Transmitter Functional Test Proposal

This document is a proposal for updating text relating to TFSEH including potential changes to the transmitter functional symbol error histogram (TFSEH) parameter and method.

Figure 180–12—Transmitter functional test block diagram

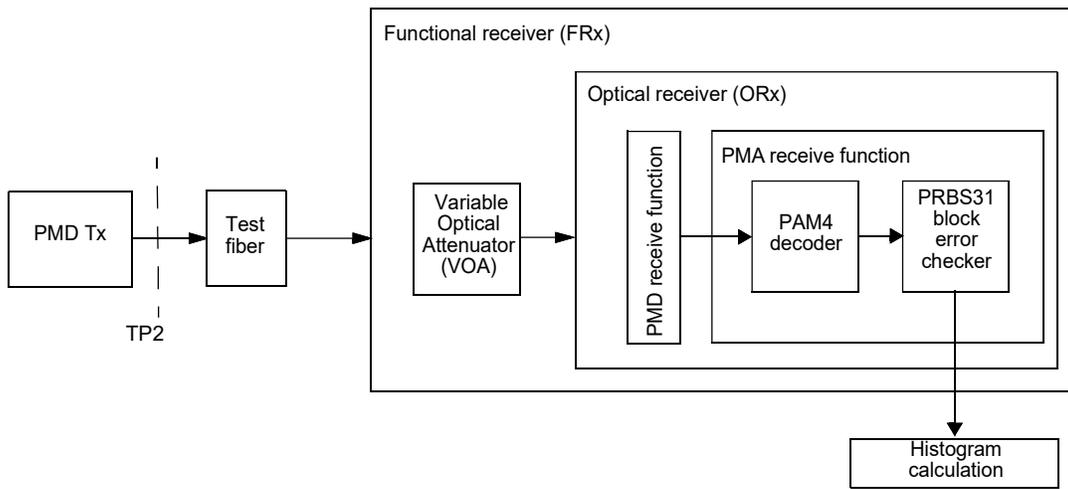
The transmitter functional test uses a functional receiver (FRx) defined in 180.9.9.1 to measure a transmitter functional symbol error histogram (TFSEH) defined in 180.9.9.2. A block diagram showing the functional receiver is shown in Figure 180–12. The transmitter under test is connected to the functional receiver by a test fiber which meets the requirements in 180.9.6.2. Full compliance with 180.9.6.2 requires the test fiber to provide back reflection with polarization state resulting in the greatest RIN. Other test fibers, including patch cords, may be used for additional tests.

The transmitter under test is configured with precoding set appropriately for the functional receiver being used in the test. The appropriate precoding state may be communicated via the ILT function or by other means.
